I refer to your telephone call concerning a planning application for a house and septic tank at Redgap, Rathcoole for Mr. B. Mansfield.

Register Reference : 91A/0662

Development : House and septic tank

LOCATION : Redgap, Rathcoole

SITE PLAN Scale 1:500 imp.

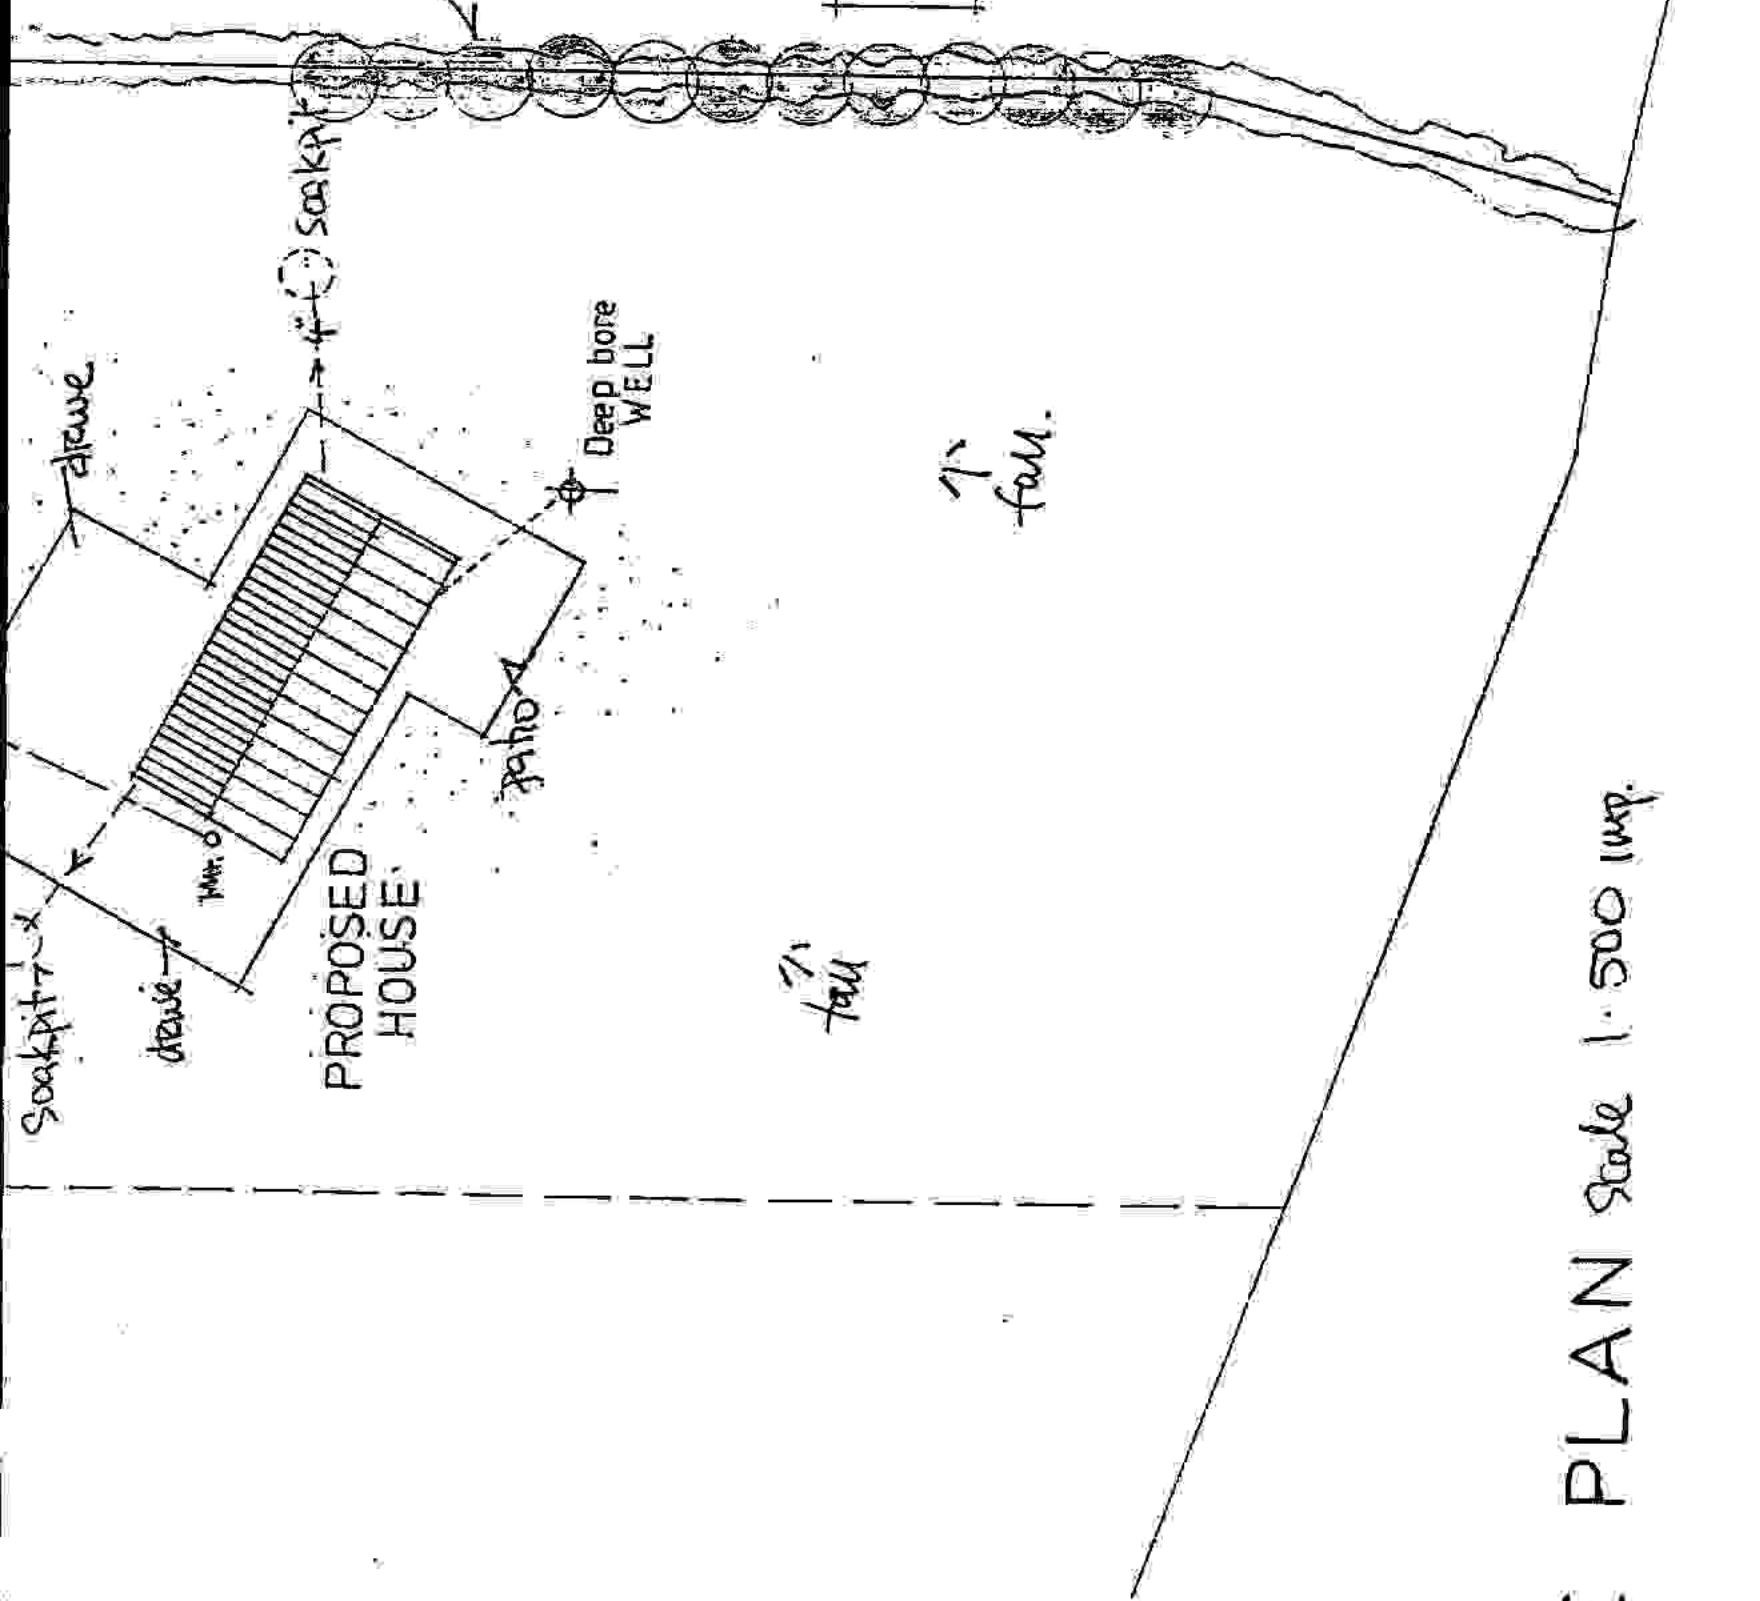
I inspected a Trial Hole opened in a
revised location on this site. The soil was
very stoney and appeared unsuitable for septic tank
drainage. Trial hole 6'6" deep - dry a lot of shale.

1. Location of any neighbouring septic tanks and wells.
 2. Evidence of availability and potentiality of water supply.
 3. Permanent air vents must be provided to all habitable rooms in the house
 4. I inspected a Trial Hole on this site on 26/6/91.
 - * The soil was very stony and appeared unsuitable for septic tank drainage. Percolation tests have not been carried out to date. H. Waller - 2/7/91
- John Hall 3/7/91

- 01 The applicant is requested to submit evidence of the soil suitability for septic tank drainage to meet the requirements of the Supervising

02 Applicant is requested to submit, outlined in blue on a scaled map, the family landholding in the area of which this site forms a part together with
